ALERT SERVICE BULLETIN

412-24-198

MODEL AFFECTED: 412EP

SUBJECT: UPPER LEFT HAND TAILBOOM ATTACHMENT FITTING, SEALANT REMOVAL OF.

Figure1. Fuselage Tailboom Attachment Fitting Sealant Removal.

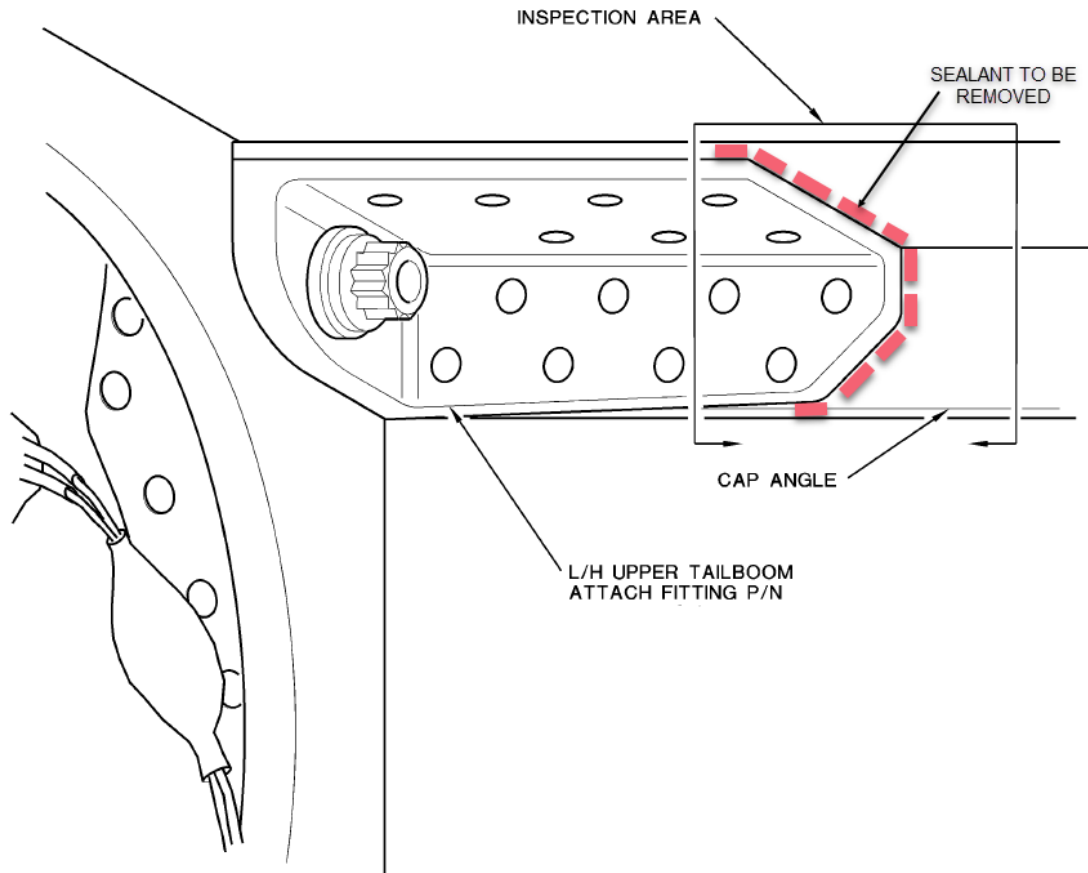
During manufacture, sealant may have been applied at the edge of the 212-030-501-101 left hand upper tailboom attach fitting where it contacts the 212-030-191-001 cap angle. This bulletin mandates the removal of the sealant to allow for proper inspection of the cap angle.

2. If sealant is present, remove sealant from edge of fitting (Figure 1).
3. Touch up primer if damaged during sealant removal. Paint touch up is optional. Do not reapply sealant after inspection.
4. Make an entry in the helicopter logbook and historical service records indicating compliance with this Alert Service Bulletin.
